SIB 72 04 17

FALSE WARNINGS THAT THE FRONT PASSENGER SEAT IS OCCUPIED WITHOUT THE SEAT BELT BUCKLED

This Service Information bulletin (Revision 9) supersedes SI **B72 04 17** dated **September 2019**.

PASSENGER OCCUPANCY DETECTION ERROR CORRECTION

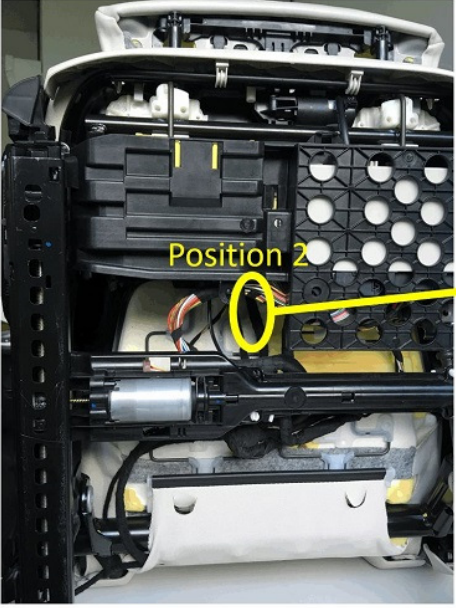
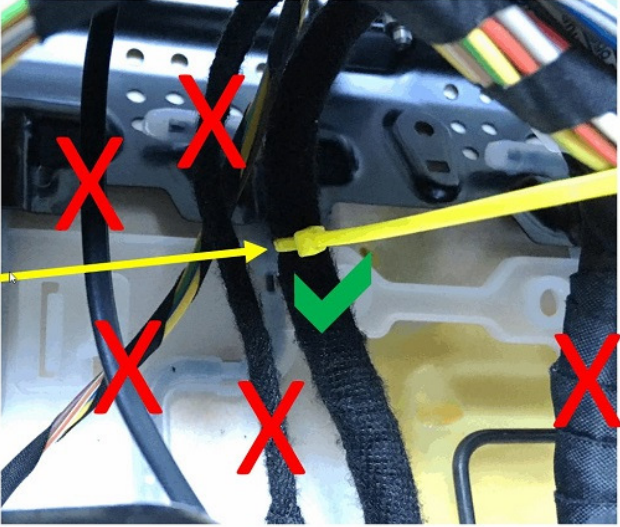
8. Secure the loose clip attached to cables, as shown.
UPDATE! For cable tie position, review the: https://tinyurl.com/V520218	
UPDATE!  Position 1 Do not attach the cable tie to any other seat parts. Just around the cable. First cable tie position as shown in above photo	
UPDATE!

Position 2	 Do not attach the cable tie to any other seat parts. Just around the cable.
Second cable tie position as shown in above photo	
	UPDATE ! 9. With the tool showing in the picture, tie the cable only around the harness.
